SD HOMES EXECUTIVE OFFICES
 Woodstock Village Commons
 110 Village Trail, Suite 113
 Woodstock, Georgia 30188

Interior Finish Plan

Reflected Ceiling Plan

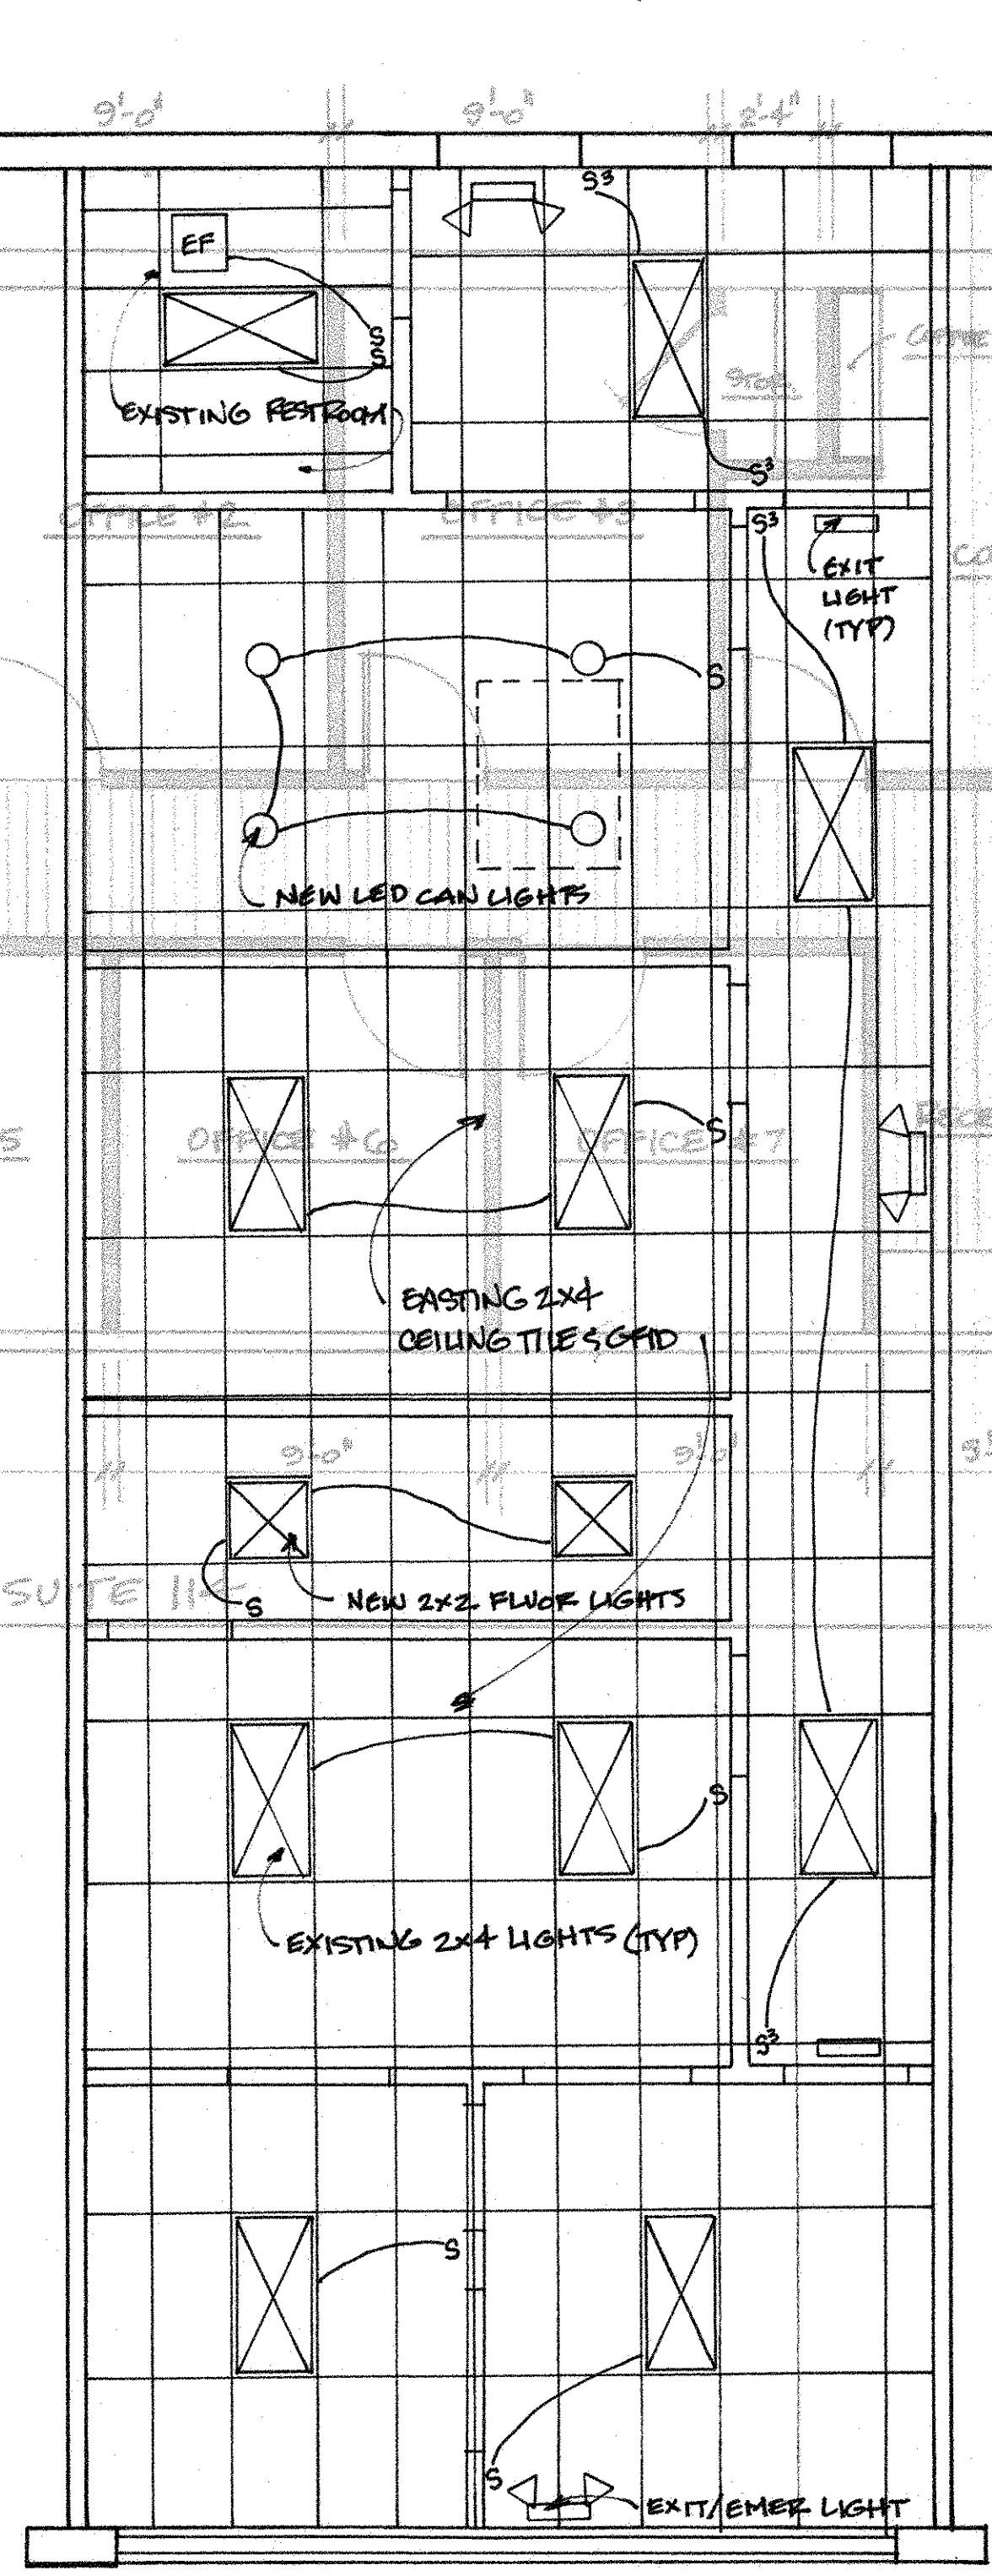
REVISIONS	BY
4/13/17. NO OUTLERS SHOWN - CORRECTED
